BRIDGE OVER T.H.&B. RAILWAY  
SUMMIT (NEAR COPETOWN)

BOREHOLE LOCATIONS &amp; SOIL STRATIGRAPHY

FOUNDATION INVESTIGATION  
SITE NO. 36-218, T.H. AND B. BRIDGE  
HWY. 52, LINE C, W.P. 99-66, DISTRICT #4  
(HAMILTON)

SUBJECT: FOUNDATION INVESTIGATION REPORT FOR D.H.O.  
BY: WILLIAM TROW ASSOCIATES LIMITED --  
Site No. 36-218, T.H. and B. Bridge,  
Hwy. 52, Line 'C', District #4 (Hamilton).  
W.P. 99-66

BOREHOLE and Cones # 2/2A/2B  
PROJECT Line C Bridge over T.H. and B. Rlwy.  
LOCATION Hwy.52, Co. Wentworth, Ont.  
HOLE LOCATION West Pier (See Dwg.1)  
HOLE ELEVATION 778.2, Cone Elevation 779.0  
DATUM Geodetic, as provided by D.H.O.

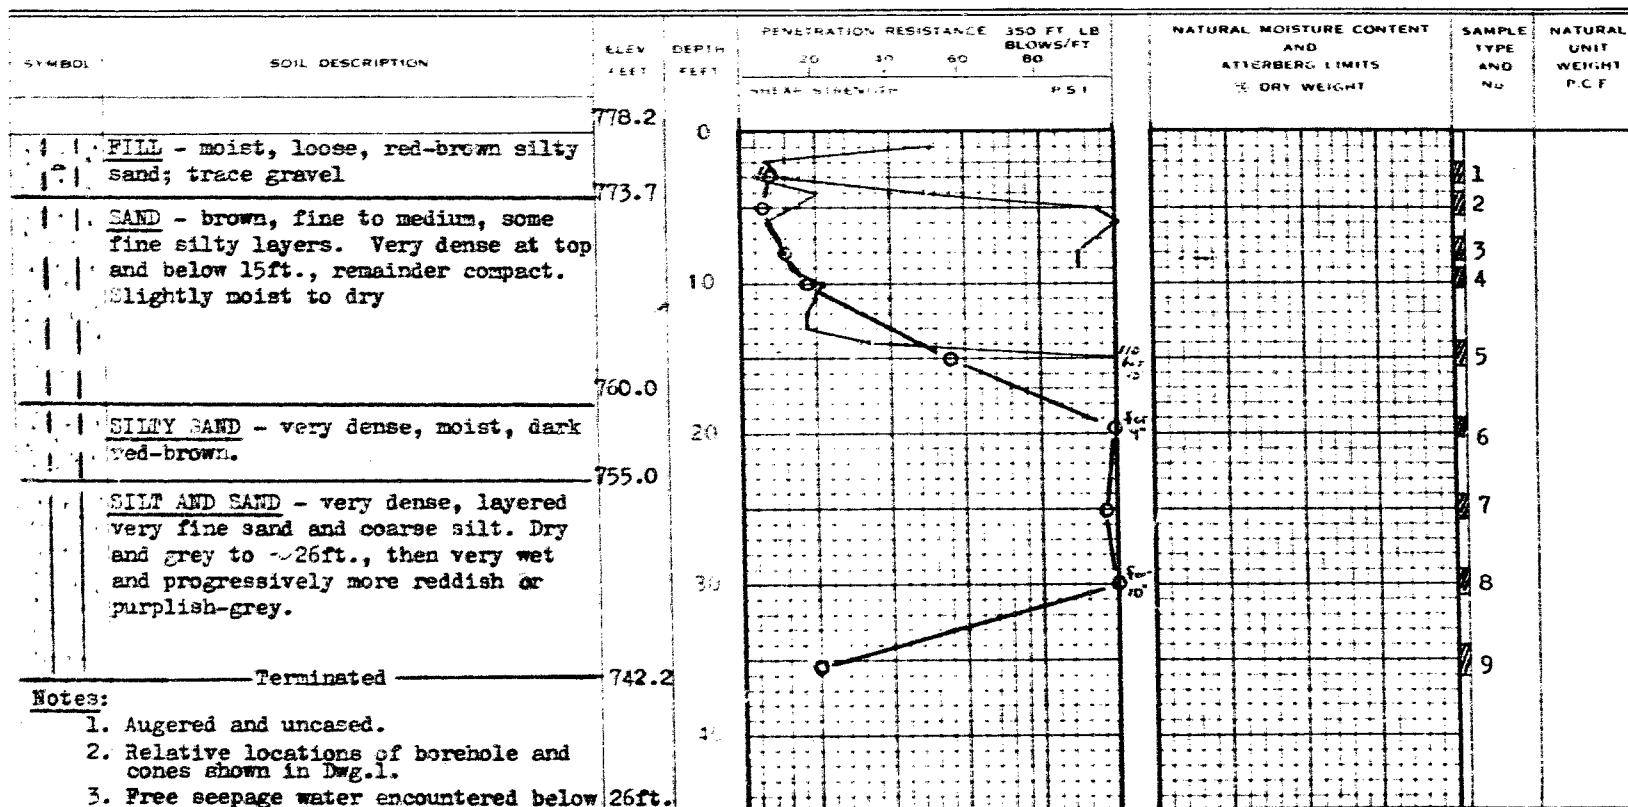
Strangely, but two borholes (No 2 & 3), stop with a rather small blow count  $N=26$  &  $18$ . It is believed that the borhole bottom was disturbed rather than the deposit becoming so much looser.
